IB12-N-001E

NO CRANK/NO START/NO SCAN TOOL COMMUNICATION - CRANK/NO START/NO FUEL PRESSURE/FUEL PUMP INOPERATIVE - EXTREME COLD WEATHER

This bulletin supersedes IB12-N-001D. This bulletin is being revised to show the locations of the X-22 and X-28 relays. Please discard bulletin IB12-N-001D.

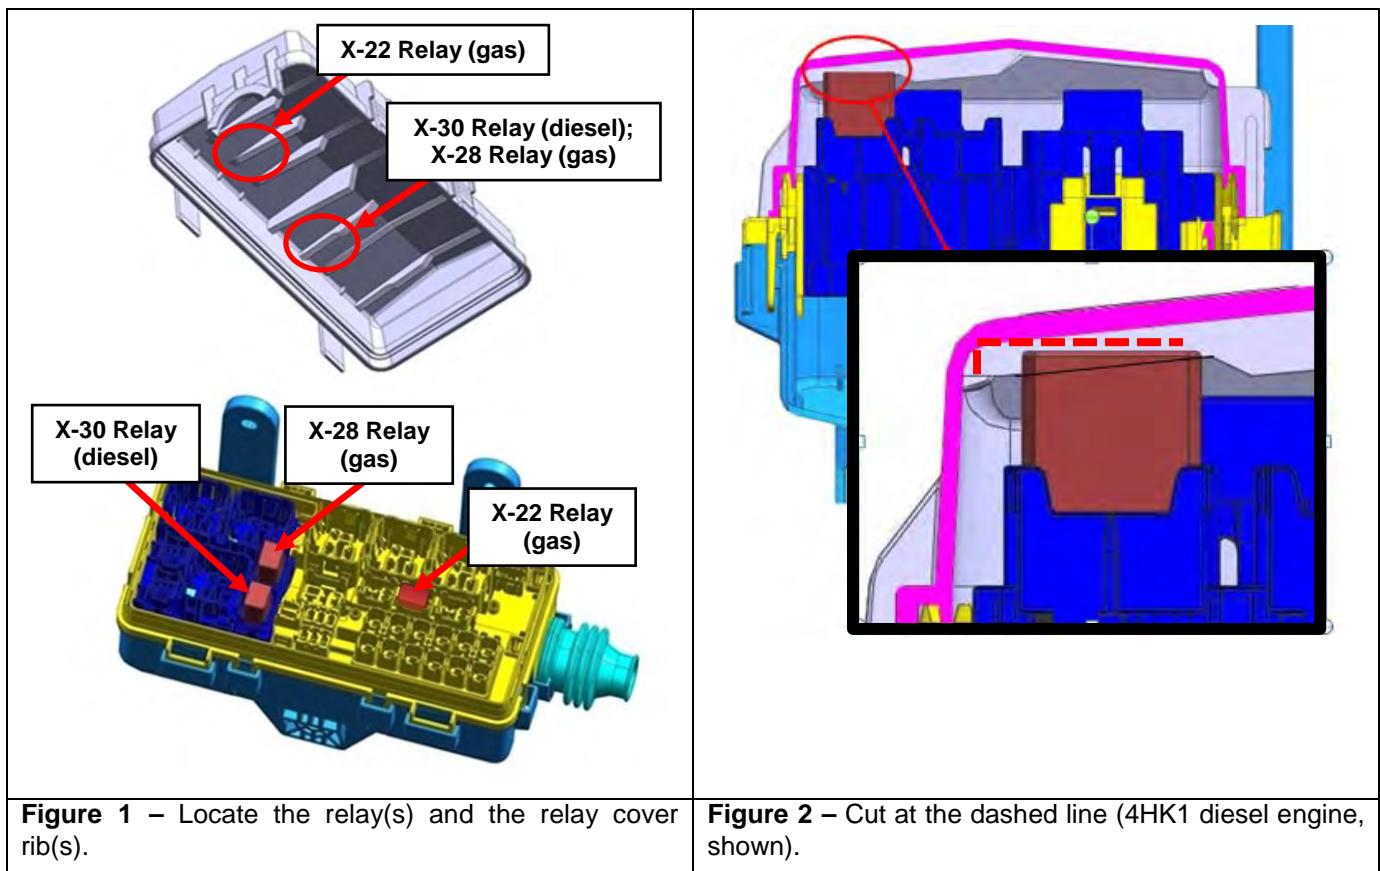
Isuzu is happy to announce the availability of a new relay with improved performance for these conditions. Installation of the new relay requires a small modification to the relay box cover. Follow the service procedure provided in this bulletin to properly install the new relay.

1. Remove relay box cover.
2. Remove the original ECM Main Relay in locations X-30 (diesel) or X-22 or X-28 (gas).
3. Install the new relay at locations X-30 (diesel) or X-22 or X-28 (gas).
4. Locate the relay box cover rib(s) as shown in Figure 1.

5. Trim the relay cover rib(s) approximately 3mm to provide clearance for the new relay(s).
6. Install the relay cover and confirm it seals properly. If the cover does not close properly, trim additional material from the cover until it correctly seals.
